UNITED STATES PATENT AND TRADEMARK OFFICE

10/595,166

Yizhak Pitkary

DETAILED ACTION

FIG. 15

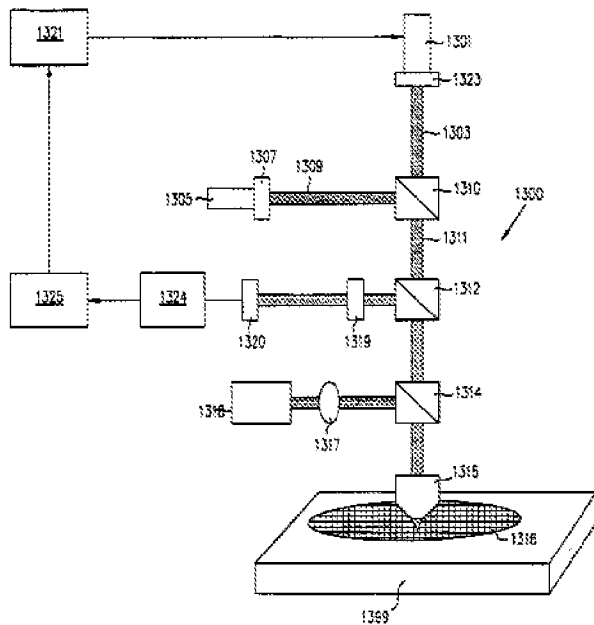
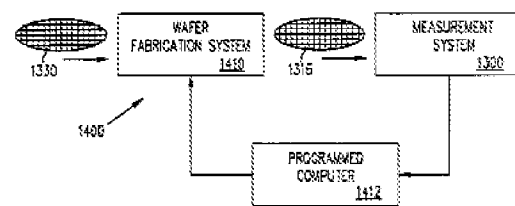
In re claim 12, Borden '791 discloses in figures 15-16 a system (1300) for testing a PCB (1316) by checking energy diffusion through board tracks comprising:

controlled heat energy source (1301, 1321) for applying heat at certain ports of the PCM (entry ports) (col. 7, lines 36-43);

thermal imaging means (1305, 1307, 1309, 1310, 1311, 1312, 1319, 1320, 1324, 1325) for measuring in time domain the rate of energy diffusion along the tracks of the board at terminating ports (col. 13, lines 40-67 to col. 14, lines 1-6);

processing means (1412, fig. 16) for comparing said measurements with prememorized values of a group of patterns that represent respective golden board results and analyzing defects automatically on the basis of learned defect test patterns (col. 8, lines 17-22).
